DESIGN REVIEW RECOMMENDATION

SDCI #3040275-LU
6102 14th Ave NW
Seattle, WA 98107

Applicant:
Cone Architecture
1319 N 49th Street
Seattle, WA 98103
Contact: Emily Terzic

NORTH WINDOW WELL ENLARGED SECTION

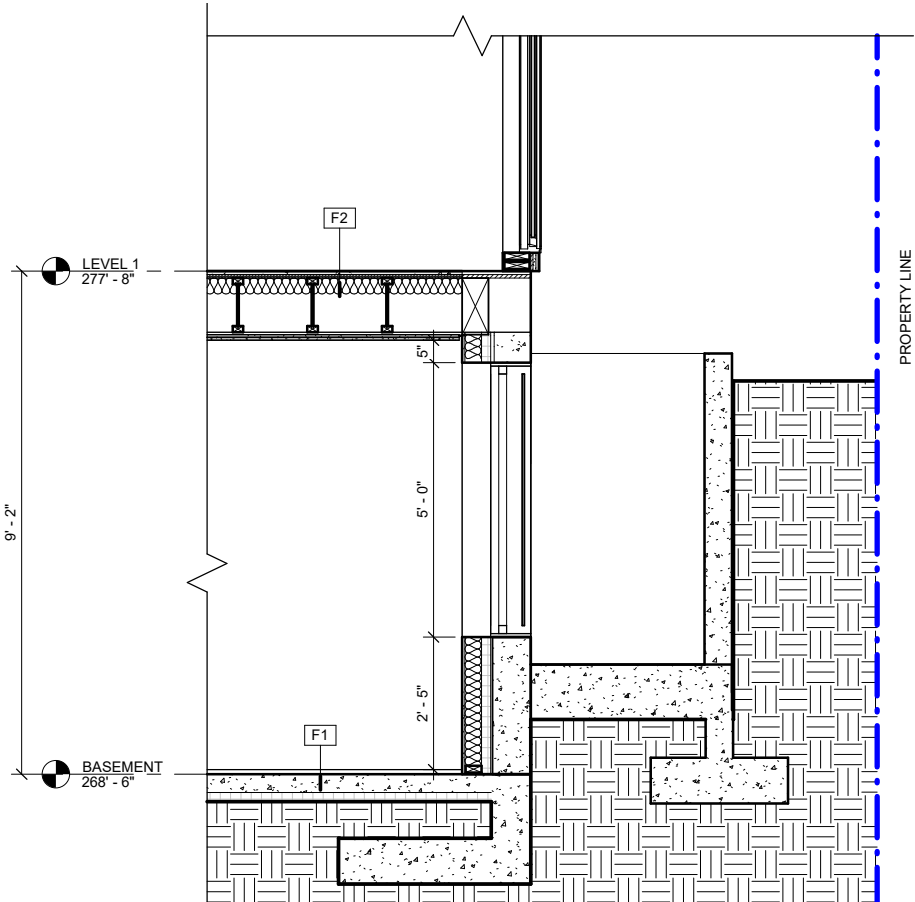
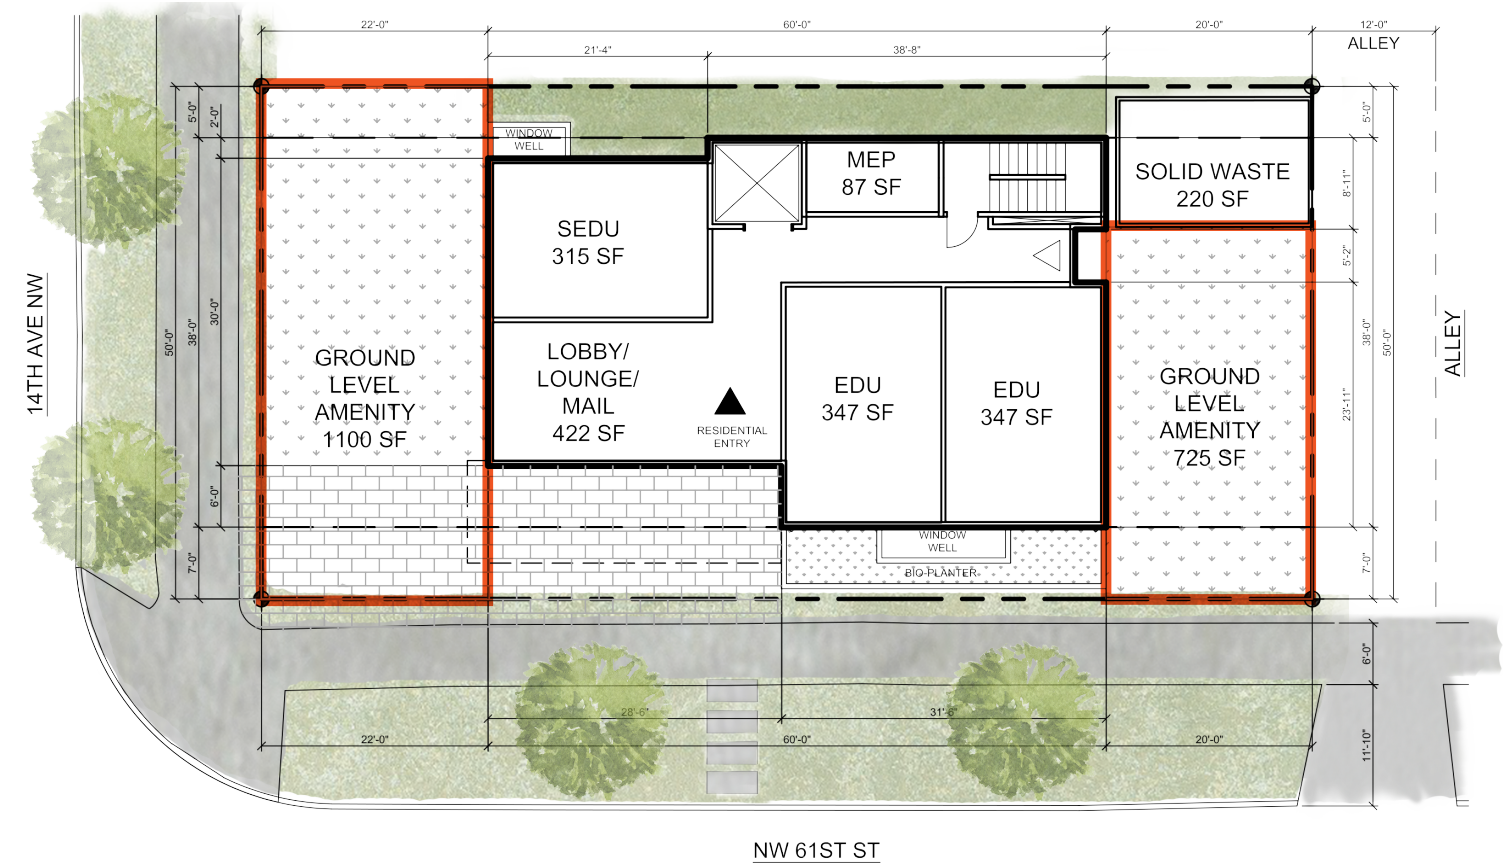
The Board requested additional information at the Recommendation phase of review to demonstrate the livability of basement-level units related to the availability of light. Information provided at Recommendation should include section drawings of the window wells (CS1-B-2. Daylight and Shading, PL3-B-2. Ground-level Residential)

Glazing has been maximized at the north and south basement units, as seen in the two enlarged sections, to optimize livability and access to light and air.

EDG PREFERRED OPTION SITE PLAN

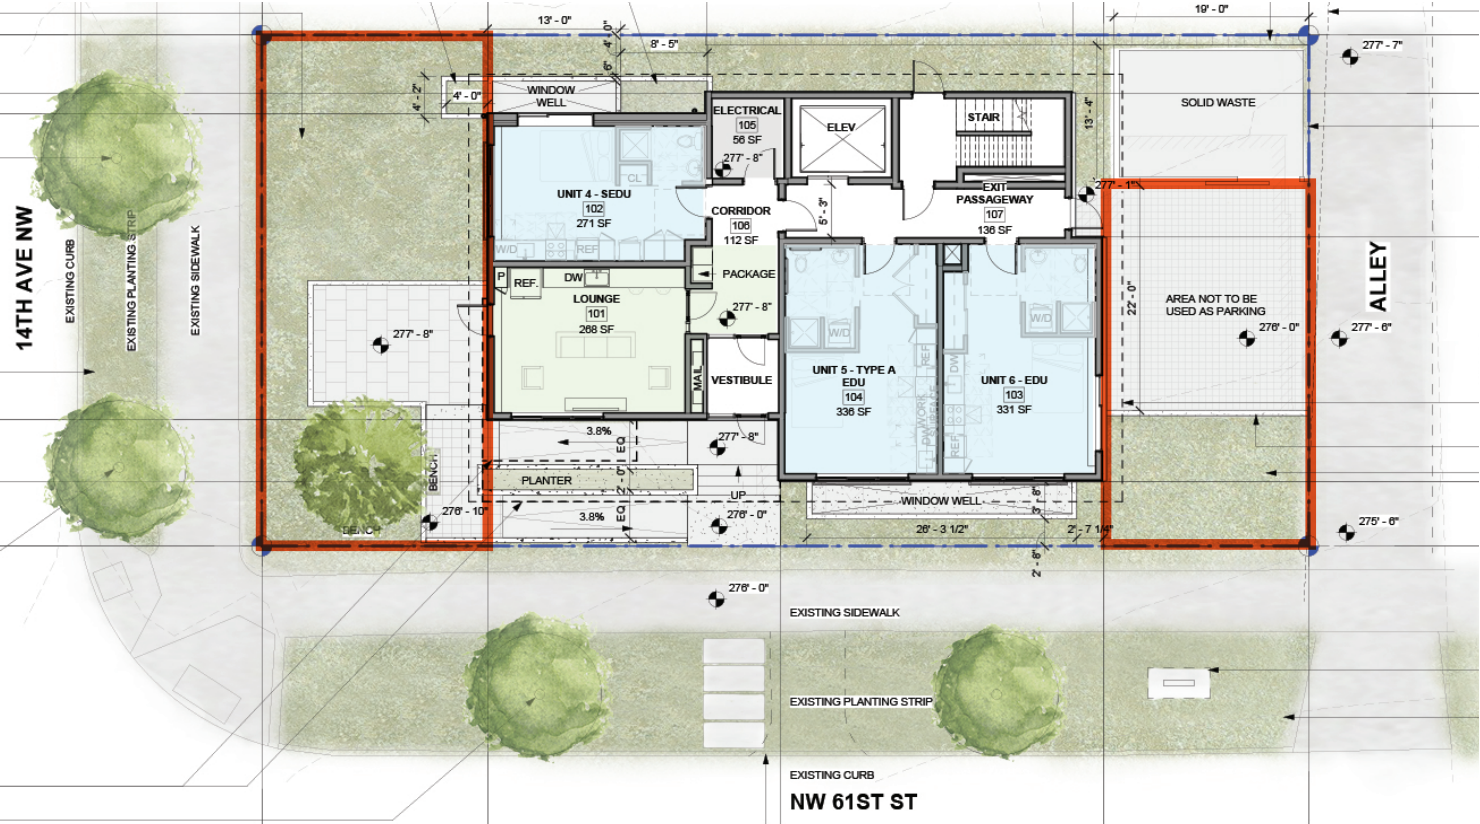
The Board generally supported layout of Option 3 with separate amenity spaces on the east and west sides of the site, stating that the western space relates well to Gemenskap Park, while the rear setback provided by the eastern space allows for an appropriate zone transition to the east.

The size of the proposed open spaces has been maintained from Option 3 at EDG. See the adjacent diagrams outlining the amenity spaces proposed at the EDG meeting for the preferred massing along with the proposed design.

AERIAL VIEW

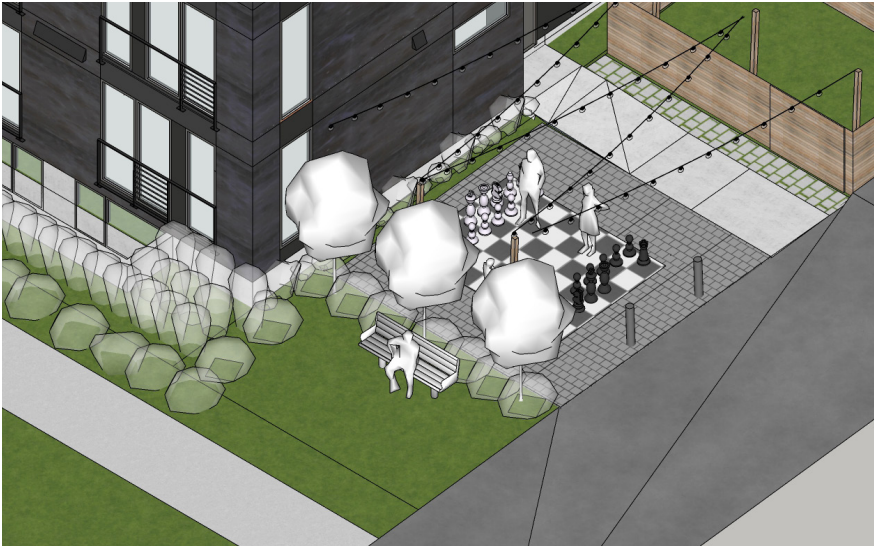
The Board requested additional information at the Recommendation phase of review illustrating how the design and programming of the east and west outdoor amenity spaces will provide comfortable and usable open spaces that meet the needs of residents within the site. The Board cited the relatively small residential units within the building and promoted the need for a range of public and private areas within these outdoor spaces.

The provided amenity spaces support the small residential units within the building through varied sizes and the possibility of multiple functions. The western amenity space is accessed directly from the interior amenity room, acting as a front patio for the ‘living room’. With two green spaces on either side of the patio, there is a balance of fencing and greenery for screening.

To transition from the street to the building, a feature tree and bench is provided along the sidewalk to aid in the transition from public to semi-private as seen in the western amenity space image. To minimize circulation spaces, the entry ramp accesses both the residential entry and the outdoor patio. A second bench is located on the enlarged ramp landing, creating a second semi-private aid from the busy street to the buildings western amenity space.

The hardscaped eastern amenity space is pulled away from the sidewalk with open area and a landscape buffer to separate the two spaces. The hardscaped amenity is intended to function for fames, sports, and larger gathering (i.e. dinner parties).

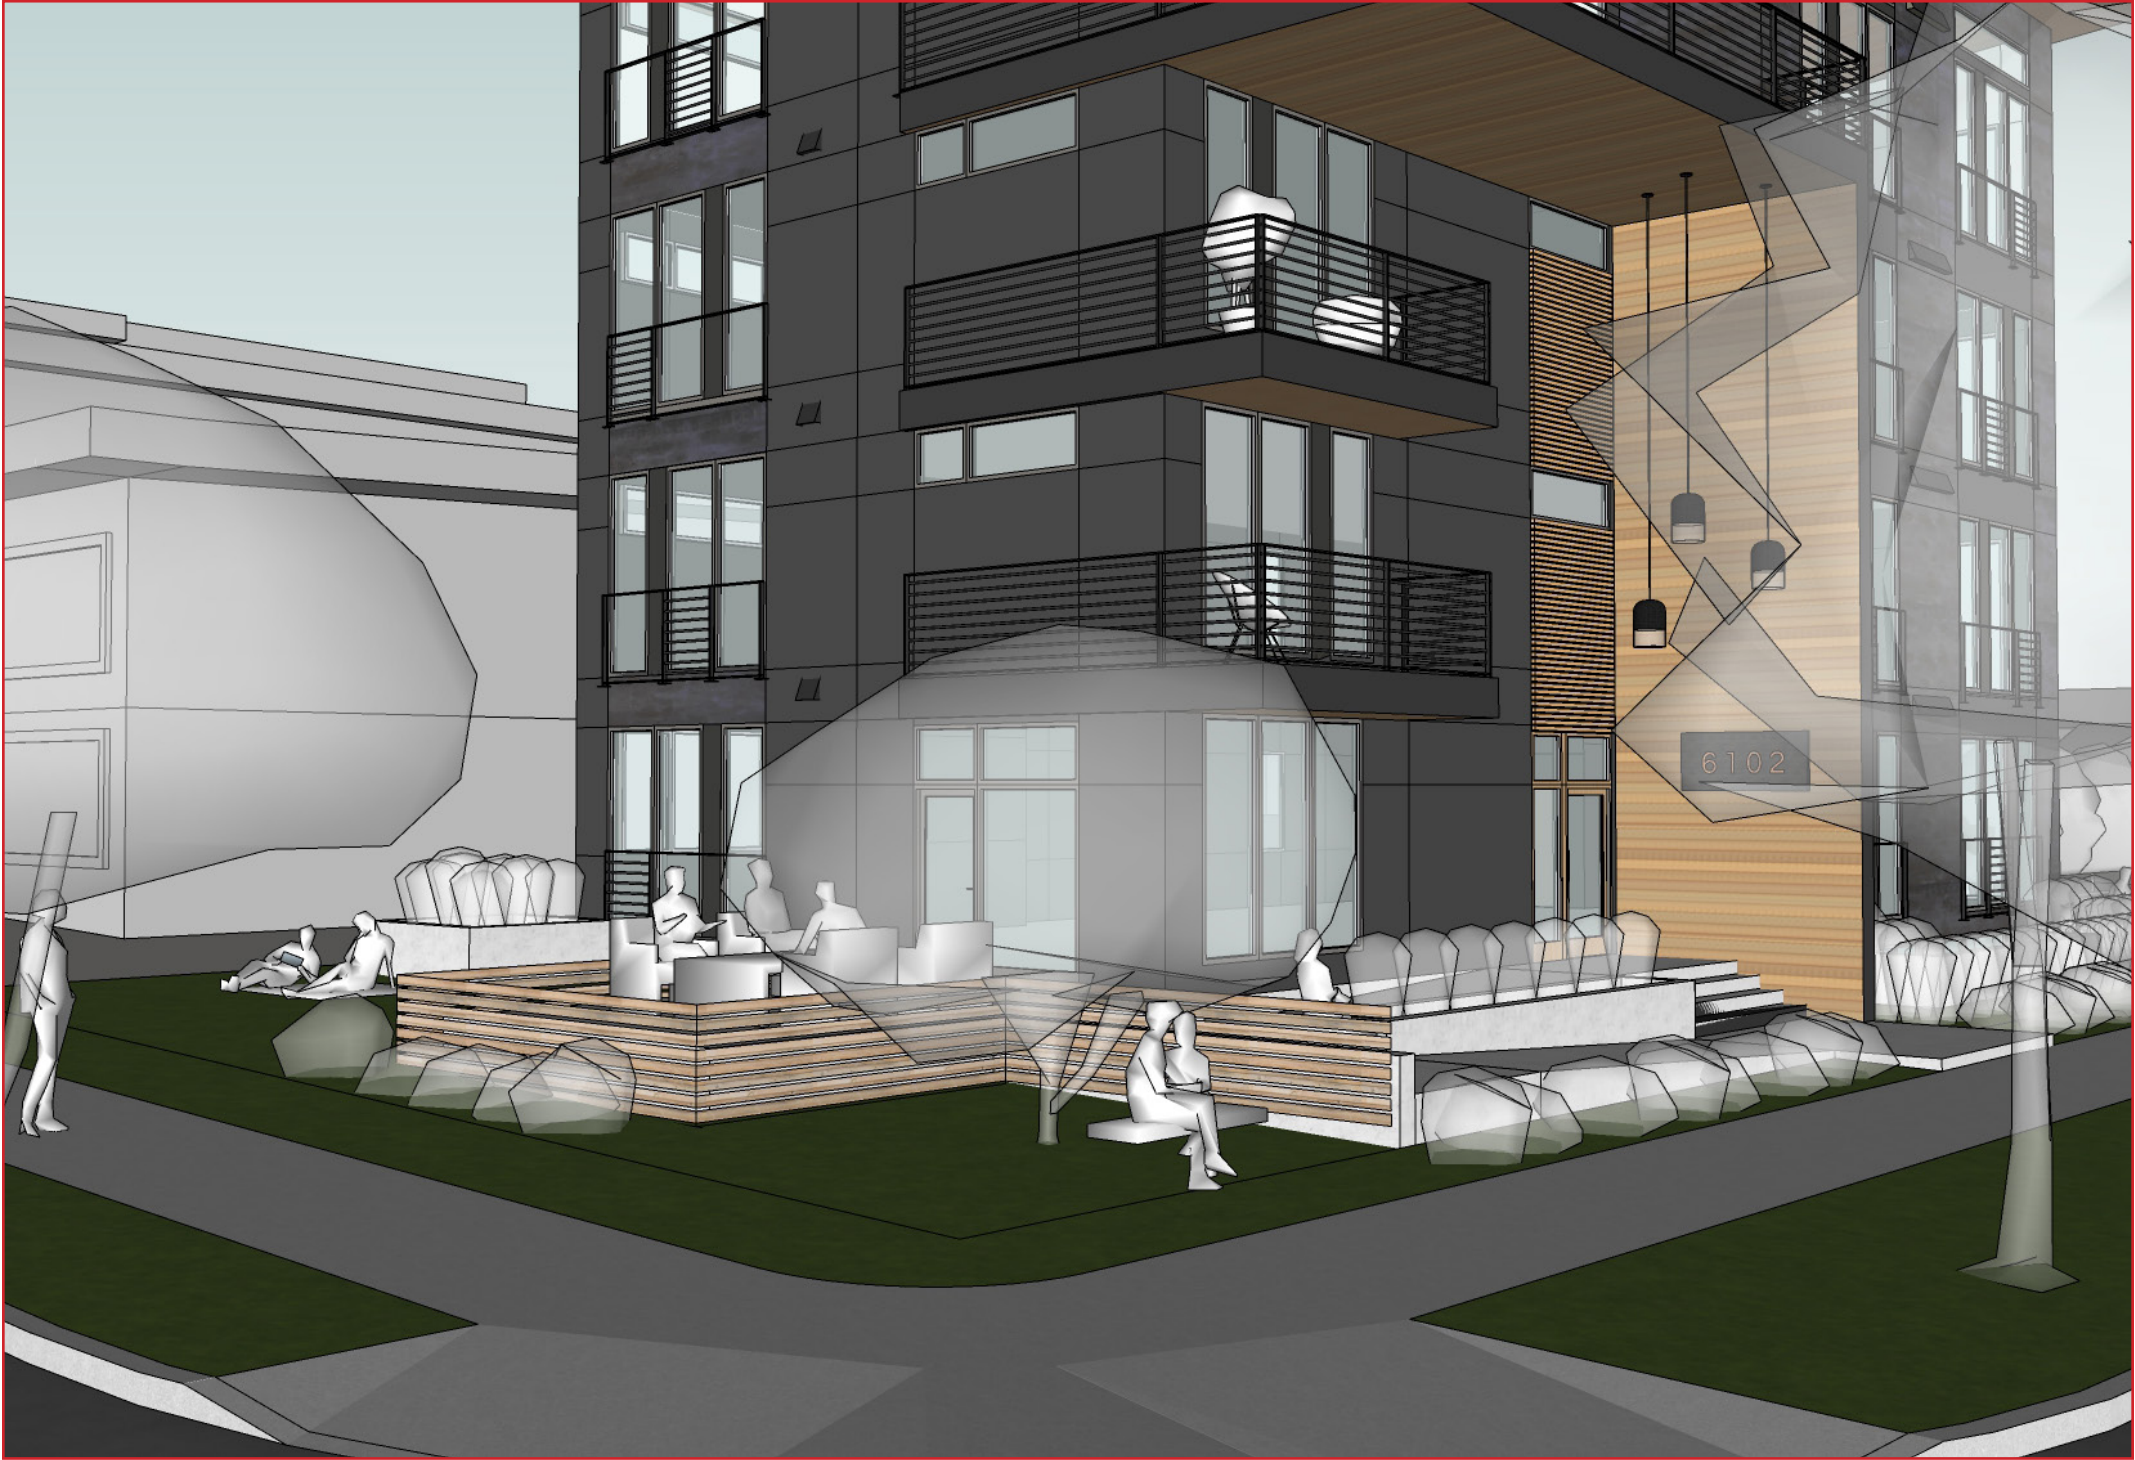
The Board supported the intent for the placement of amenity spaces along street frontages in Option 3 and emphasized the need to maintain physical and/or visual interaction between the amenity spaces and the street frontages by minimizing the heights of fences and other physical barriers along street frontages.

The proposed design maintains a visual connection from the hardscaped amenity spaces at the southwest and southeast corner of the site to the adjacent sidewalks. Vertical separation is provided by a small retaining wall and while there is a fence being proposed at the southwest corner, it is low enough to maintain eyes to the sidewalk.
